Service Bulletin

Bulletin SB 2016
(Same as SB-059)

SUBJECT: DC Voltage Protection Circuit for KR-5400, KR-4400, and KA-4006

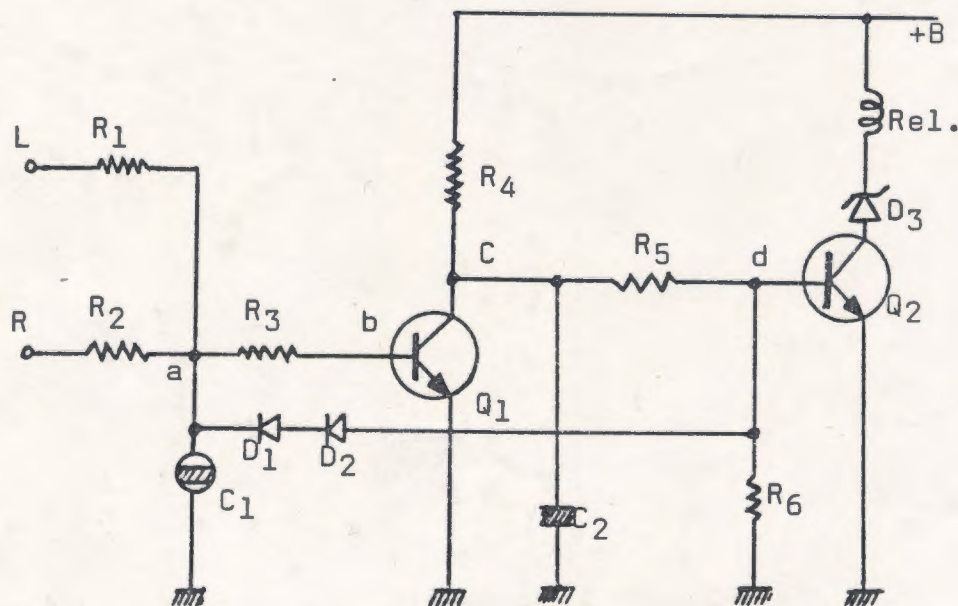
A production change has resulted in the use of a new DC voltage protection circuit in the KR-5400, KR-4400, and KA-4006. The change applies to those units of the above model whose serial numbers are 06XXXX or higher.

The basic circuit layout for the new protection circuit and a brief description of its operation is provided below:

- 1) Left channel output signal (or R-Ch output signal) is applied to point "a" through R1 (or R2).
- 2) AC output signals are bypassed via C1 to ground and do not activate the circuit.
- 3) If a positive DC voltage appears at "a", this voltage is applied to the base of Q1 (point "b") through R3.
Because of the increased base voltage Q1 is turned on and the Q1 collector voltage decreases. As a result, the voltage at "d" also decreases and Q2 is turned off.
- 4) If a negative DC voltage appears at "a", this voltage appears at "d" through D1 and D2, so that Q2 is turned off.
- 5) R4 and C2 have a time constant. Therefore, there is a time delay after the power switch is turned on until the relay closes.
- 6) D3 (Zener Diode) improves the switching characteristic of Q2 and allows a quicker release of the relay when the power switch is turned off.

<u>OLD MAIN AMP UNIT</u>	<u>NEW MAIN AMP UNIT</u>
KR-5400	X07-1280-10	X07-1350-10
KR-4400	X07-1280-11	X07-1350-11
KA-4006	X07-1280-12	X07-1350-12

NOTE: THE NEW BOARDS ARE NOT INTERCHANGEABLE WITH THE OLD BOARDS.
